HISTORIC AND DESIGN REVIEW COMMISSION

HDRC CASE NO: 2024-404
ADDRESS: 362 E HUISACHE AVE
LEGAL DESCRIPTION: NCB 3088 BLK 4 LOT 15
ZONING: R-4, H
CITY COUNCIL DIST.: 1
DISTRICT: Monte Vista Historic District
APPLICANT: Anthony Chen/Aeonium Investments LLC
OWNER: BEAM GREGORY & ALISON
TYPE OF WORK: Conceptual review for rear detached garage construction
APPLICATION RECEIVED: November 25, 2024
60-DAY REVIEW: January 24, 2025
CASE MANAGER: Bryan Morales
REQUEST:

The applicant is requesting conceptual approval to construct an approximately 360 sf detached rear accessory structure.

FRONT ELEVATION

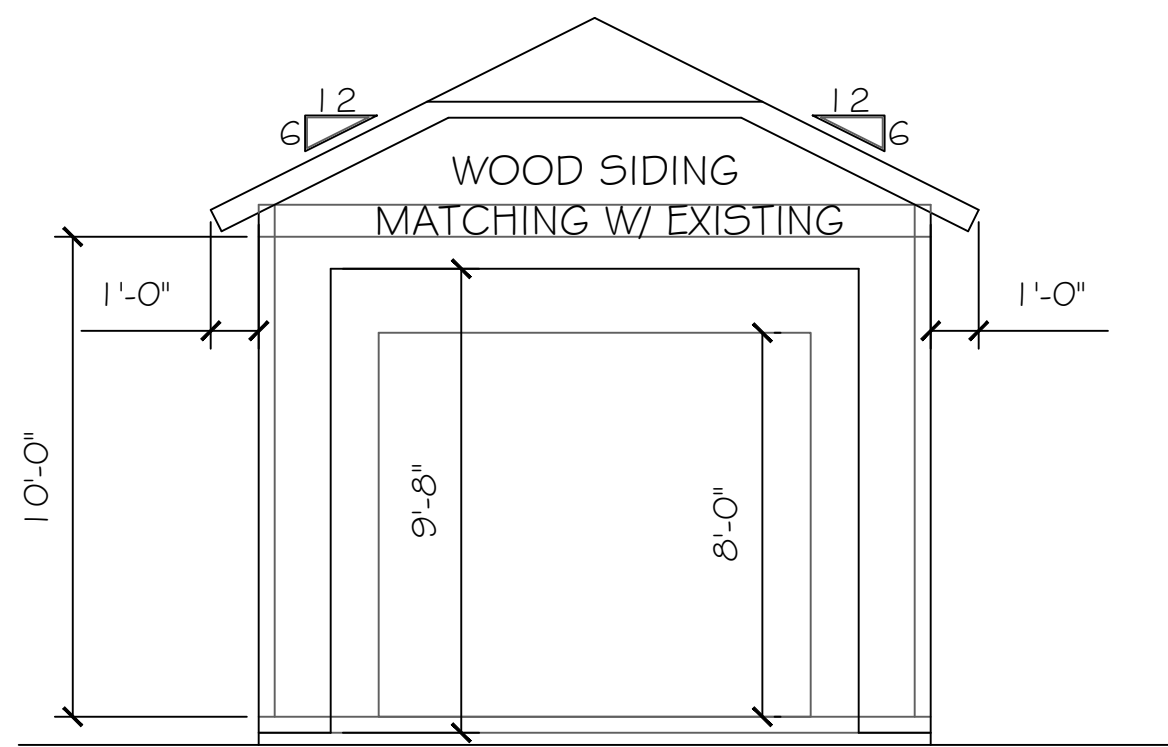
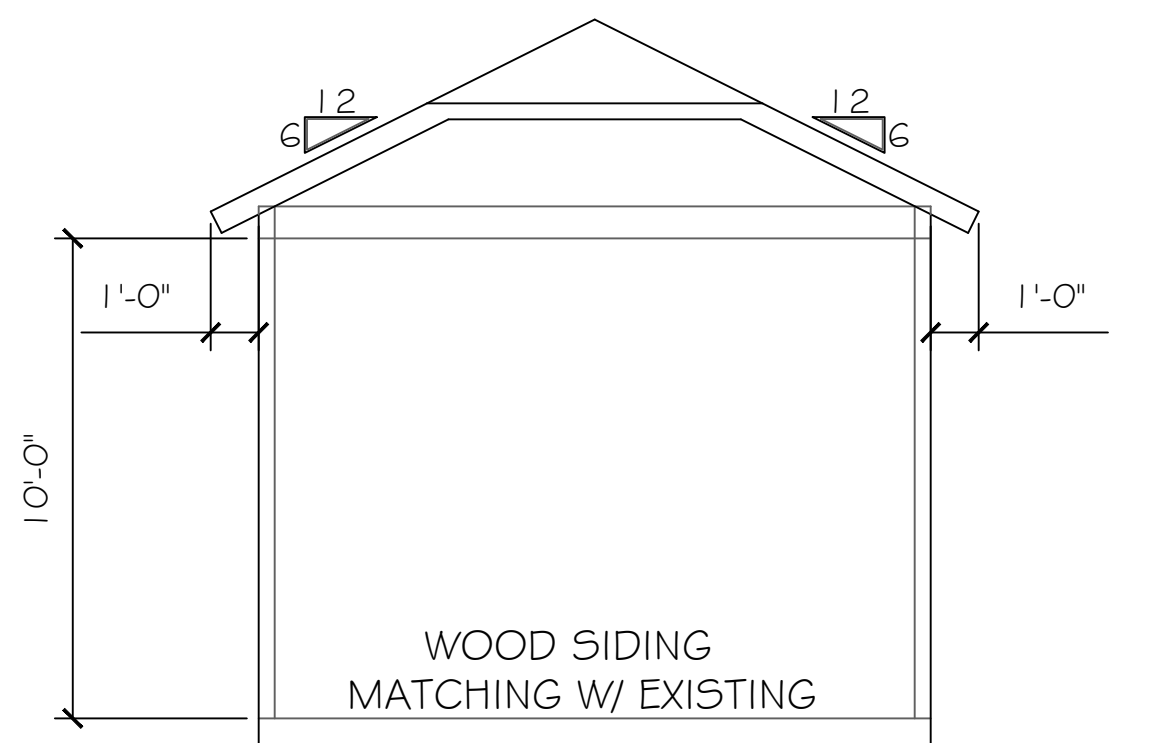
- f. ARCHITECTURAL DETAILS (FENESTRATION PATTERN) – The applicant is proposing to install one Craftsman wood door on the right façade, one garage door on the front façade, and three clerestory windows on the right façade. The Guidelines for New Construction 2.C.i. related to window and door openings stipulates to incorporate window and door openings with a similar proportion of wall to window space as typical with nearby historic facades. Staff finds the proposed fenestration pattern generally appropriate; however, the applicant should incorporate single-sashed windows on the right façade rather than the requested clerestory windows.

- ii. That the applicant install a fully wood garage door or a garage door with a design that mimics wood construction and features a smooth finish without a faux wood grain texture. Final garage door specifications must be submitted to staff for review and approval prior to the issuance of a Certificate of Appropriateness.
- iii. That the applicant meets all setback standards as required by city zoning and obtain a variance from the Board of Adjustment if applicable.

RIGHT ELEVATION

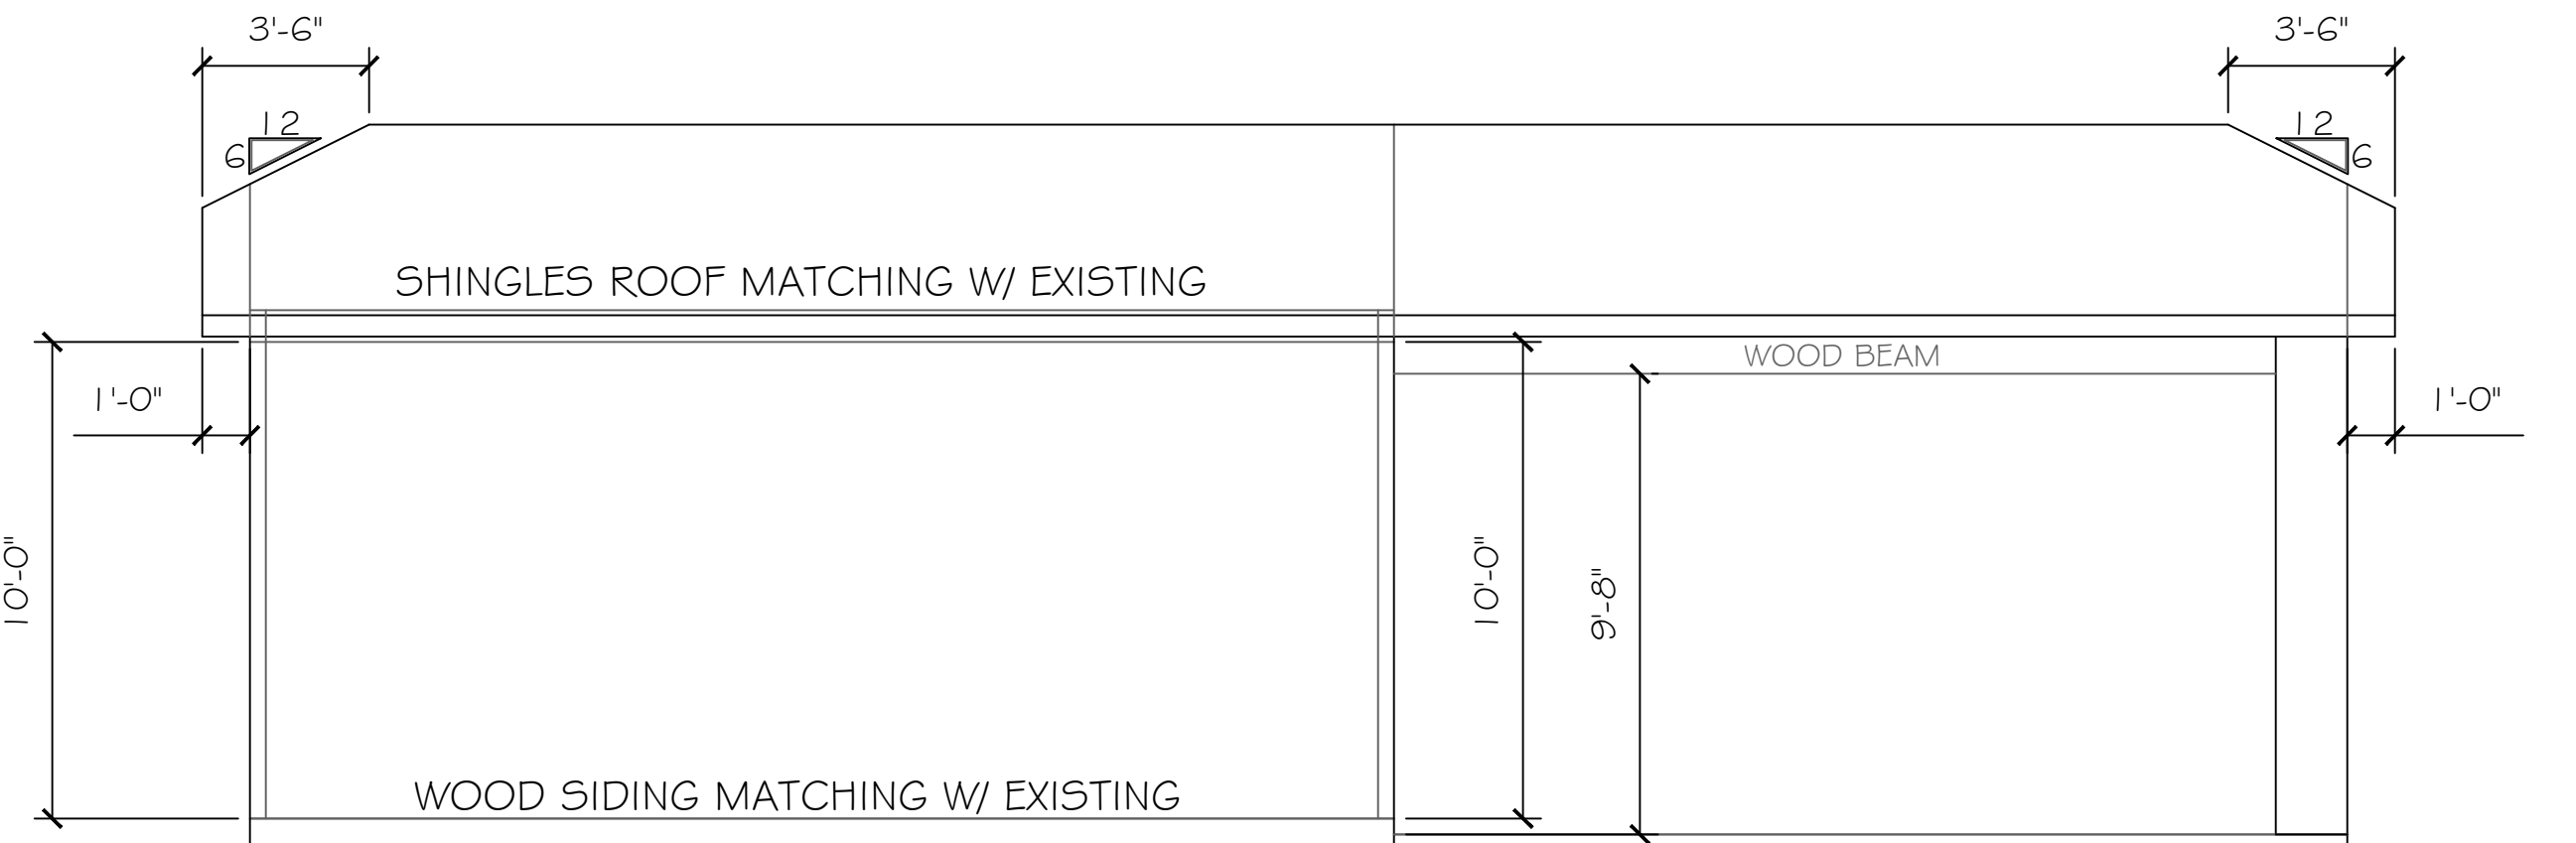
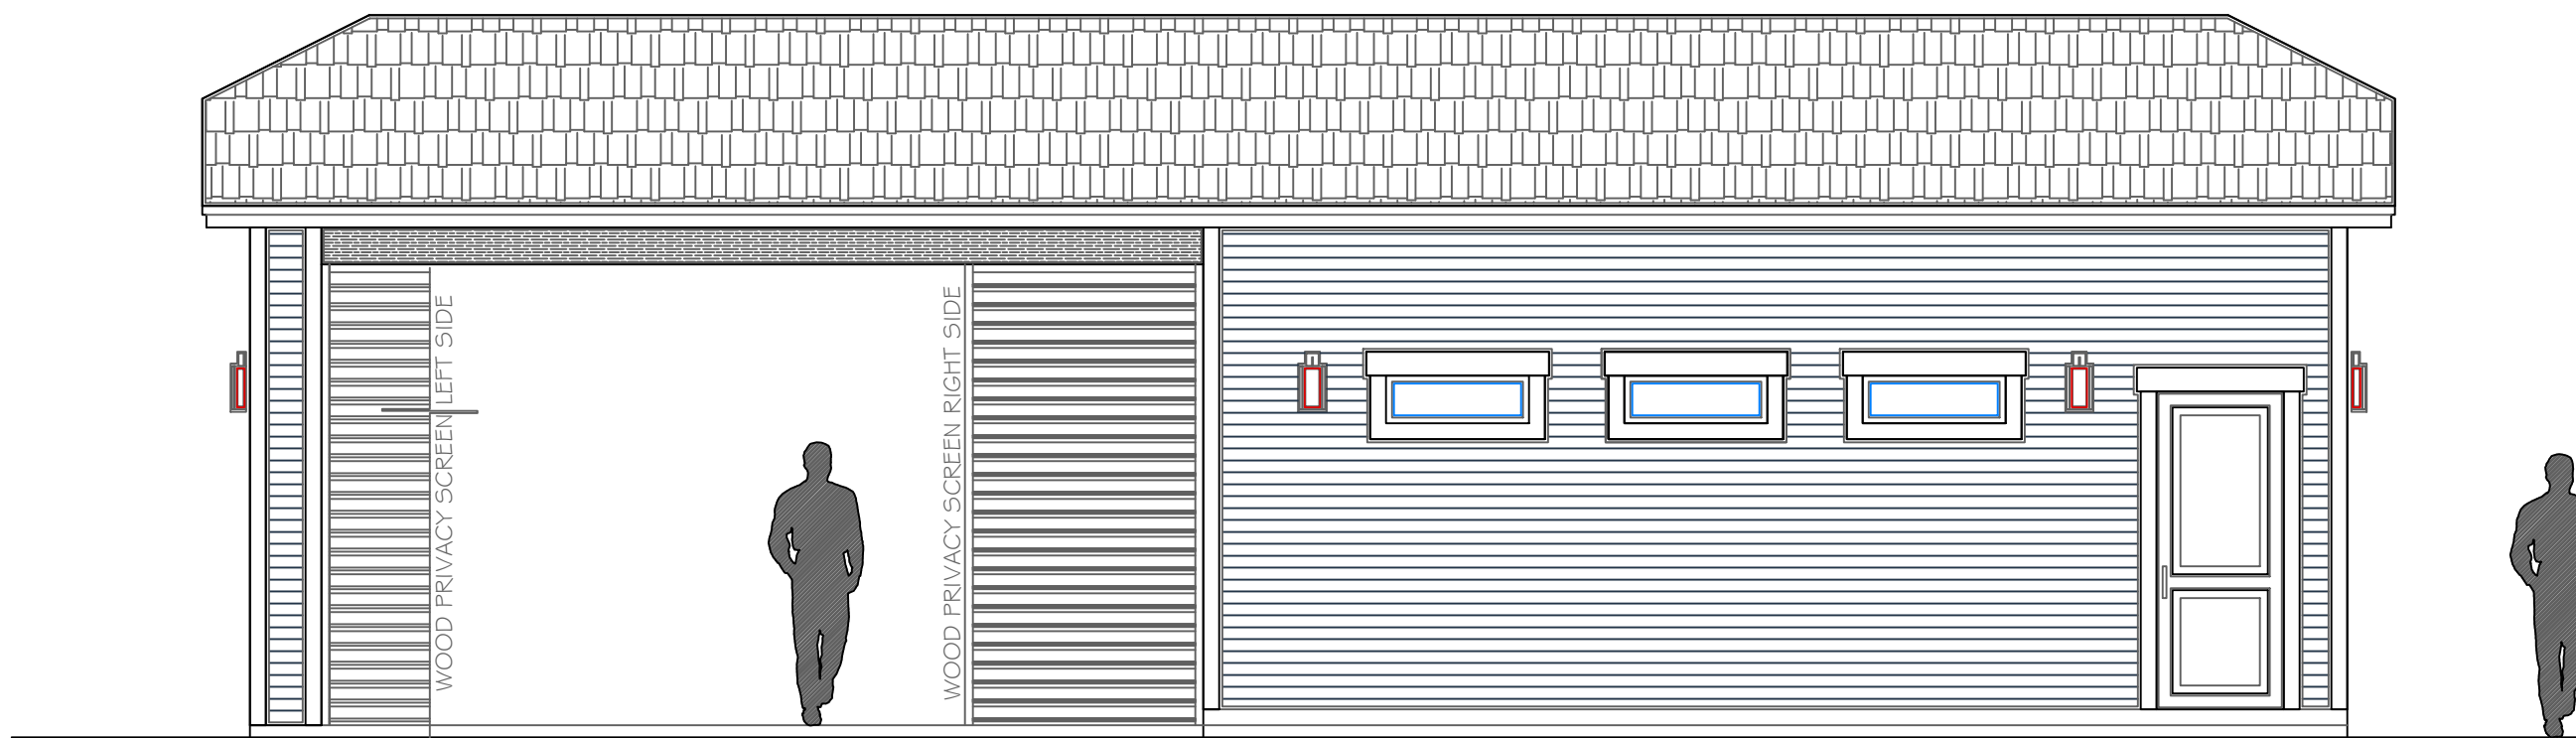
- g. WINDOWS (MATERIALS) – The applicant has not provided material information on the proposed windows on the right façade. Per *Standard Specifications for Windows in New Construction*, new windows on new construction should relate to the windows of the primary historic structure in terms of materiality and overall appearance. Windows used in new construction should be similar in appearance to those commonly found within the district in terms of size, profile, and configuration. Staff recommends that the applicant install wood or aluminum-clad wood windows on the rear accessory structure. An alternative window material may be proposed, provided that the window features meeting rails that are no taller than 1.25" and stiles no wider than 2.25".

- i. That the applicant installs a fully wood or aluminum-clad wood window that meet staff's standard window stipulations and submits updated specifications to staff for review and approval. The windows should feature an inset of two (2) inches within facades and should feature profiles that are found historically within the

immediate vicinity. Meeting rails must be no taller than 1.25” and stiles no wider than 2.25”. White manufacturer’s color is not allowed, and color selection must be presented to staff. There should be a minimum of two inches in depth between the front face of the window trim and the front face of the top window sash. This must be accomplished by recessing the window sufficiently within the opening or with the installation of additional window trim to add thickness. Window trim must feature traditional dimensions and architecturally appropriate sill detail. Window track components must be painted to match the window trim or concealed by a wood window screen set within the opening.
